GeoSolve Ref: 220556.03  
26 November 2025

RCL Homestead Bay Ltd  
[REDACTED]

## Request for Further Information - Homestead Bay Lot 12 DP 364700

Project:

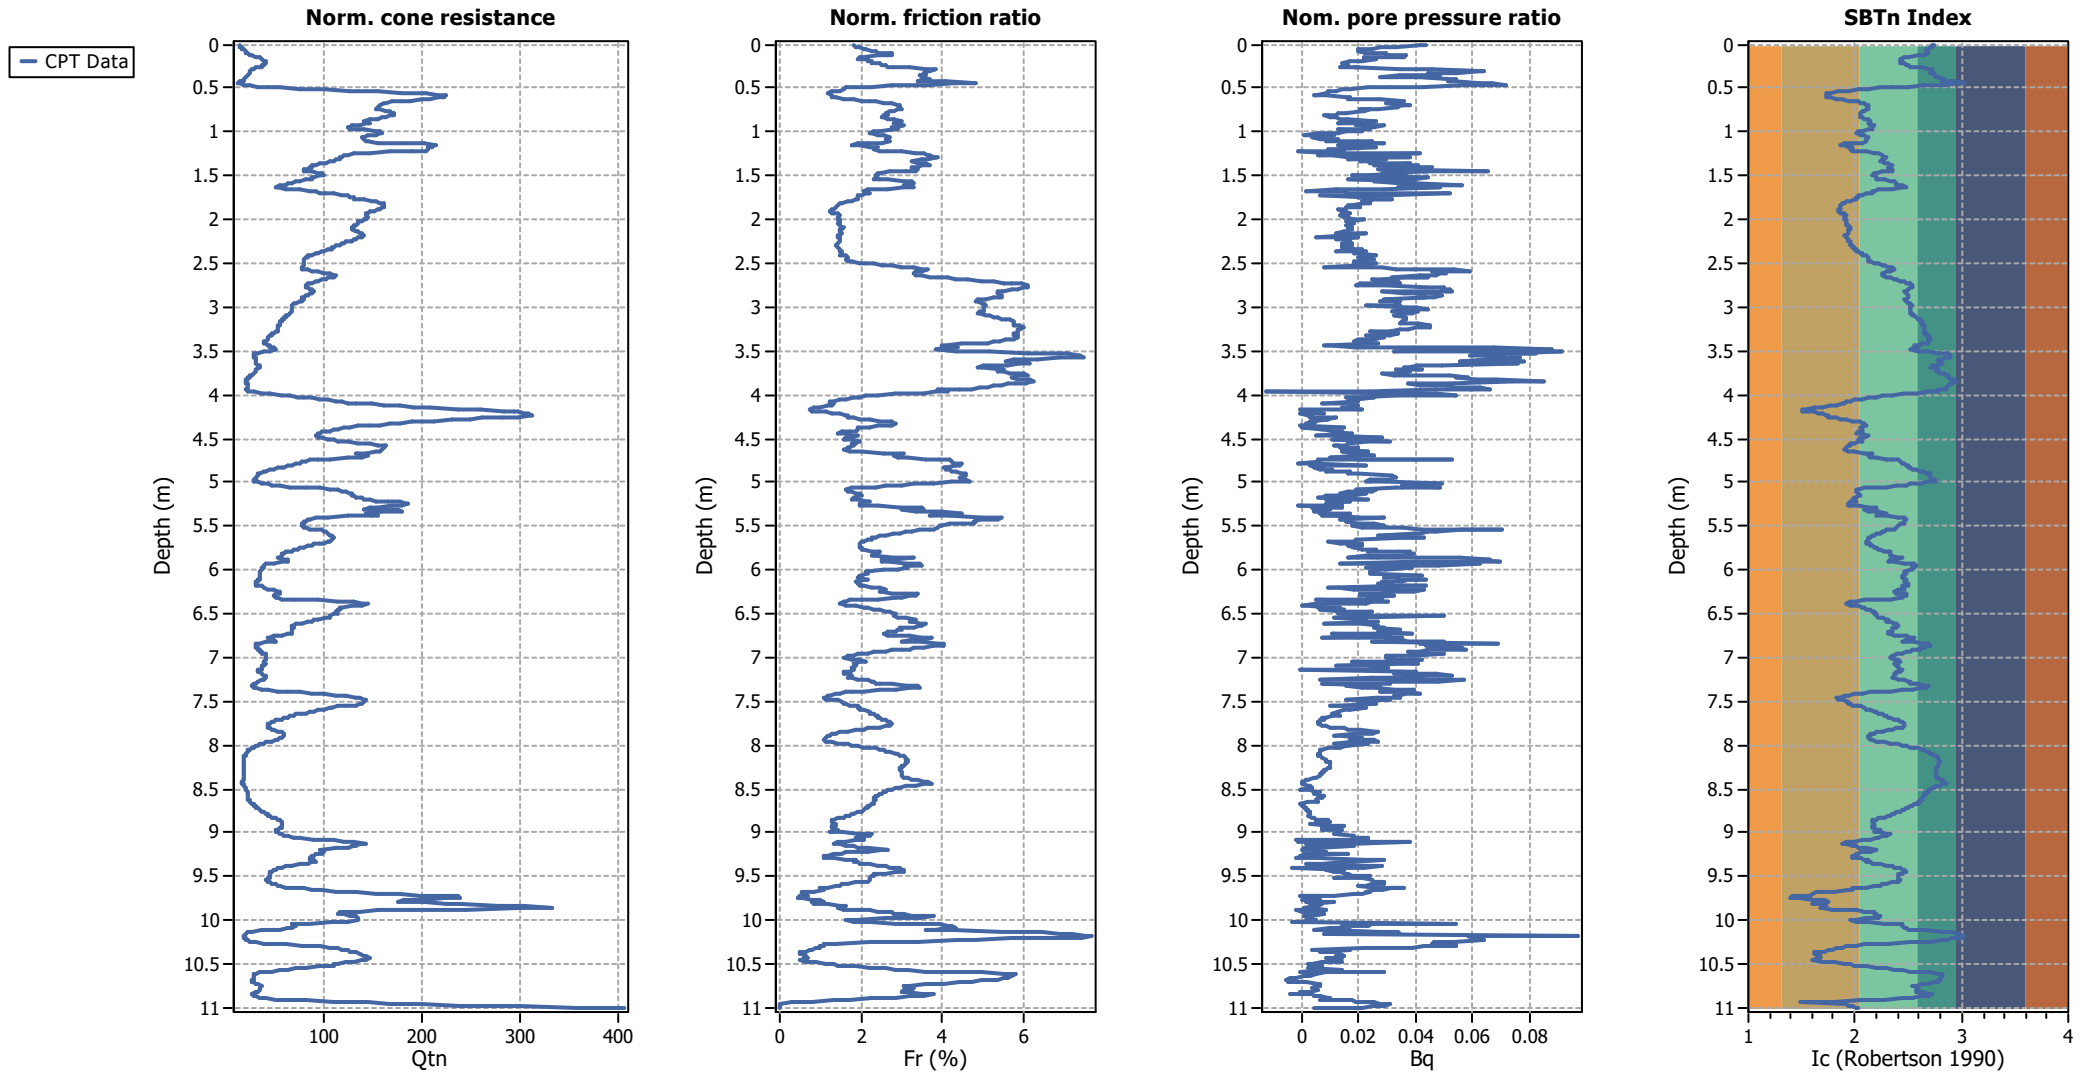
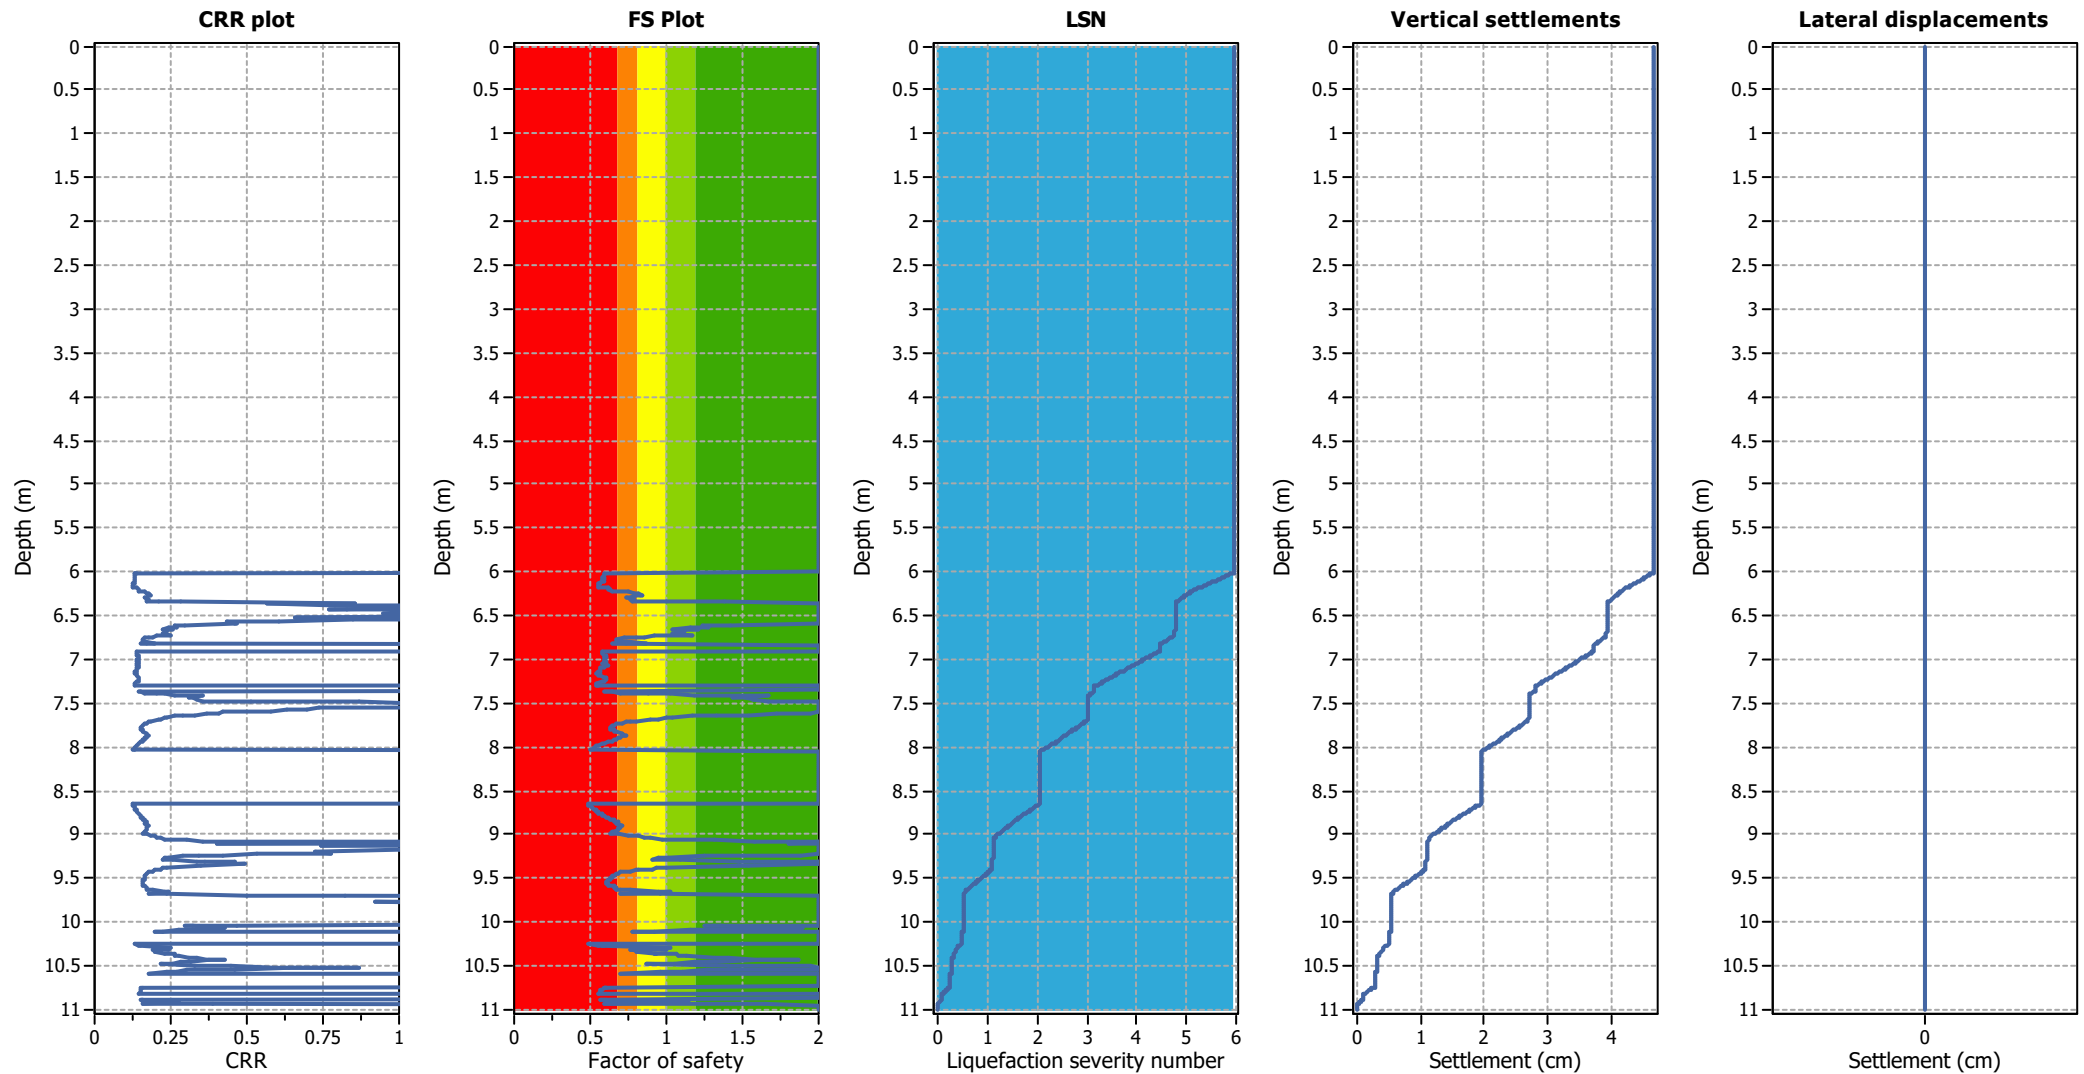
21.	The liquefaction analysis undertaken for CPT 4 was for both IL3 and IL4 – QLDC requires reservoirs and WTP to be designed for IL4, so the results for IL4 have been considered. The liquefaction analysis undertaken from CPT 4 shows settlements for IL4 SLS2 (1 in 500) and ULS (1 in 1000) of 50mm and 60mm respectively. Appendix H does not conclude the classification of the liquefaction risk, but it does refer that “the liquefaction risk to be similar to eastern areas of the wider Homestead Bay site to the south” which stated: medium vulnerability, the initial report states it can be mitigated with robust foundation slabs similar to MBIE TC2 slabs (pg 511 of Eng Report Part 2). This mitigation was provided for residential buildings.
-----	---

Based on the liquefaction assessment Geosolve consider the liquefaction vulnerability to be Medium. This is based on the following:

- Liquefaction settlements of 50 mm have been calculated for a 1/500 year event.
- Differential settlements are expected to be Less than 50 mm, but may be 25 mm;
- No lateral spread is expected.
- The calculated liquefaction for a 100 year event is <10 mm, which is considered to be none to minor.
- Larger seismic events (1/2500 yr) result in relatively minor incremental settlement.
